Procedure for step capacity contro lchang to stepless control

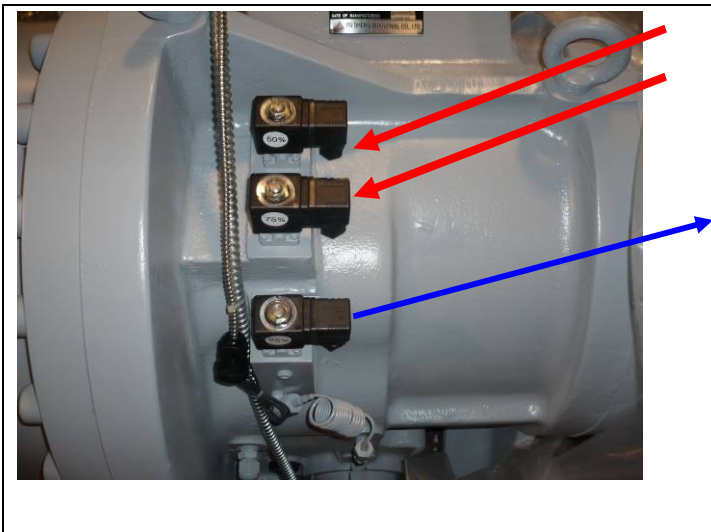
<ol style="list-style-type: none">1. Photo #1.2. Just remove the coil of NC solenoid valve 50% and 75%. Keep the body on the compressor, as photo #3 shown.3. Keep the solenoid valve 25% as usual. No need to change it.
	<ol style="list-style-type: none">1. Photo #2.2. Installing the NO solenoid valve (stepless solenoid valve). This is stepless control.3. Blind flanges.
	<ol style="list-style-type: none">1. Photo #3.2. If you don't have the blind flange and gasket3. Just remove the coil (black shell one) and make these two valves in de-energized circumstance.
